**RE: Access Logistics Park, 884-928 Mamre Road, Kemps Creek – SSD 17647189
Consolidated Stakeholder Engagement & Response to Submissions**

TABLE 1 RESONSE TO TFNSW COMMEMTS (DATED 23 DECEMBER 2022)	
Agency Comment	Response
Intersection Design and Further Information Request.	
1. TfNSW requires verification that the deceleration and acceleration lanes will satisfy Austroads requirements. TfNSW Road Design team have recommended that the deceleration lane be extended to reflect the expected traffic volumes, articulated vehicle movements, road gradients and speed of travel. An additional shoulder area is also to be provided. In addition, the ultimate arrangement needs to be consistent with the local road network in Mamre Road Precinct Development Control Plan. TfNSW requires the southbound lanes to remain consistent with MRUS2 strategic design, and the deceleration lane to be included within proposed verge and developer owned land.	The LILO design plan has been amended to ensure deceleration lane satisfies Austroads Requirements. As advised, design plan has been amended and an additional shoulder area has been provided (refer to the amended design plan (2021_19_SD_0001_SK0007D Issue

Figure 1: Mamre Rd / Access Logistics LILO (without acceleration lane)

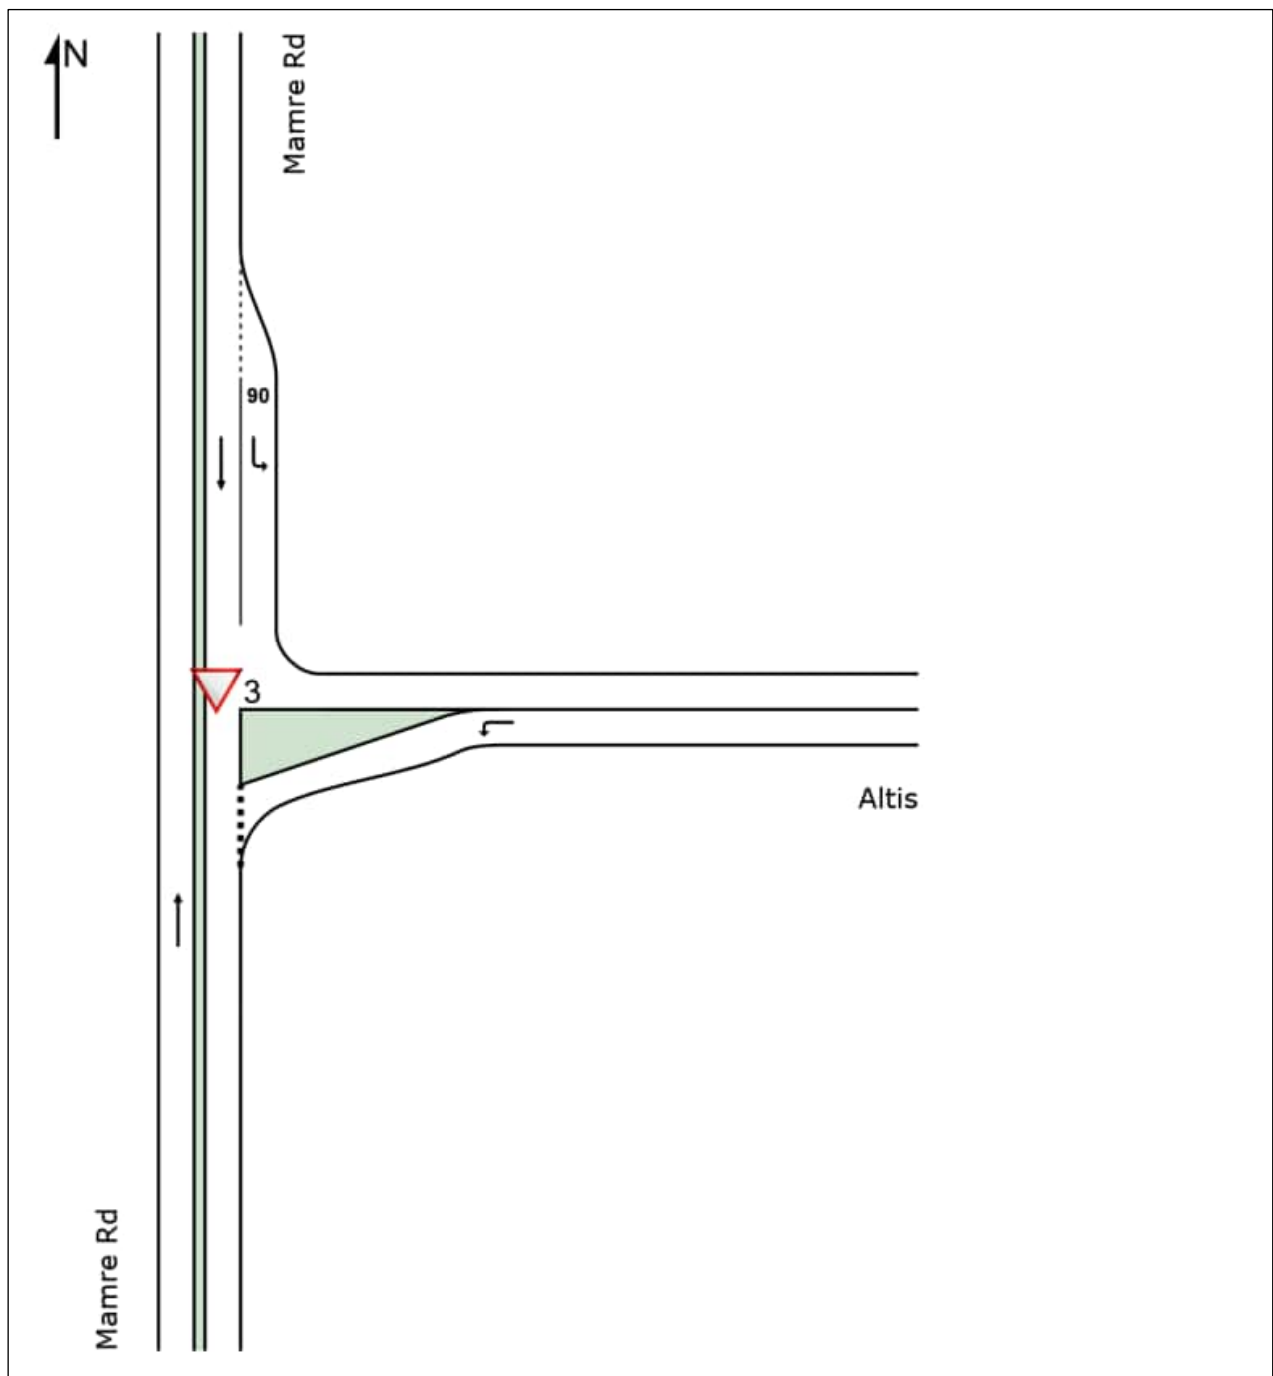
As outlined above, TfNSW has raised concerns regarding the previous modelling being undertaken in isolation of other development in the area and also with the design of the left-out acceleration lane from Access Logistics Park. The concept of an acceleration lane at this location is established by the DCP and deemed supportable from a design perspective (refer separate MU Group response).

Notwithstanding, additional traffic modelling has been prepared for the following scenarios to inform assessment of this particular development and to seek TfNSW direction with regard to the design of the Mamre Road / Access Logistics intersection:

It is requested that TfNSW provide guidance on which option it would prefer (with or without acceleration lane) so that relevant documentation to support the SSD can be finalised.

5. The development can be supported in isolation via the left-in, left-out (without acceleration) prior to further background growth on the network as a result of regional traffic and other developments.
6. In the medium-term (2026), development can be supported via The LILO intersection (with acceleration lane), as originally intended
7. Removal of the acceleration lane in the median will result in additional delays at both the Access Logistics LILO and Aspect Industrial Estate signals
8. Longer term (2031 & 2036), further investment by Government is required to deliver the necessary infrastructure to support the broader Mamre Road Precinct.

Figure 2: Existing (2022) + Development (Access Logistics Only)

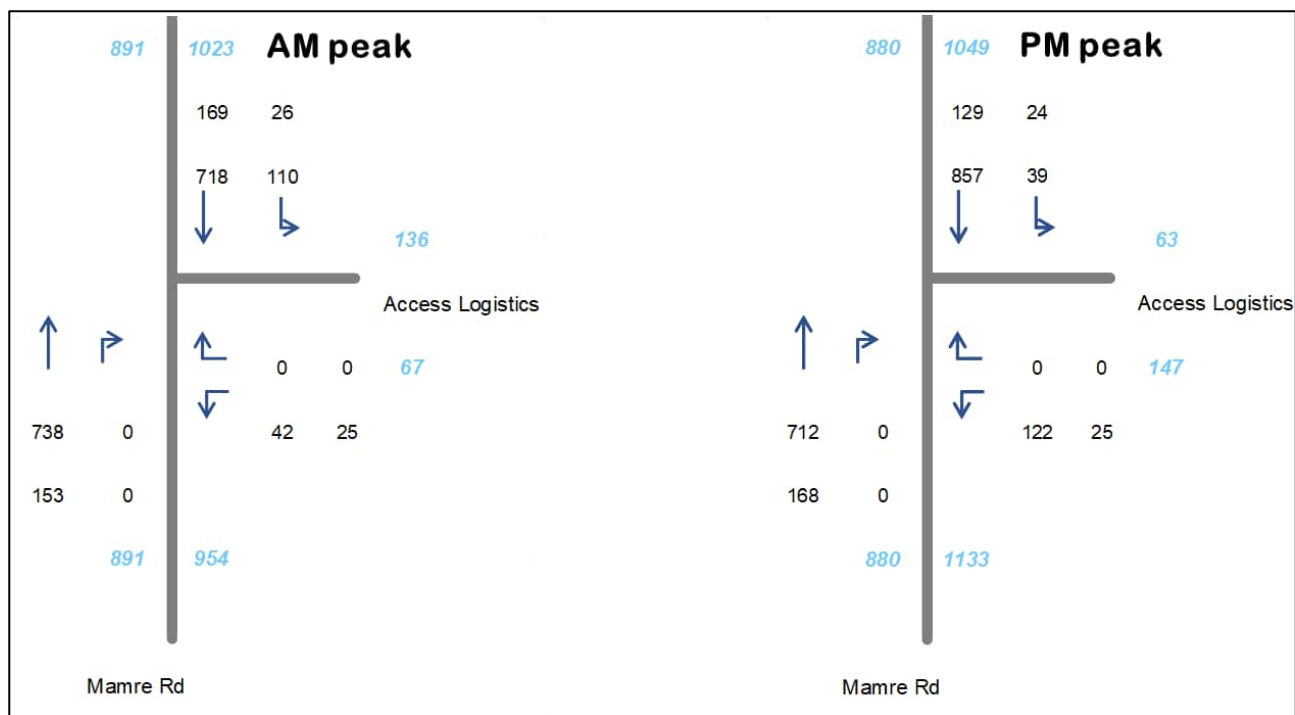
For Scenario 01 (2022+Development), we have adopted the following traffic volumes. Figures closest to the arrows represent “light vehicles” (i.e. cars) and the other relates to “heavy vehicles” (i.e. trucks).
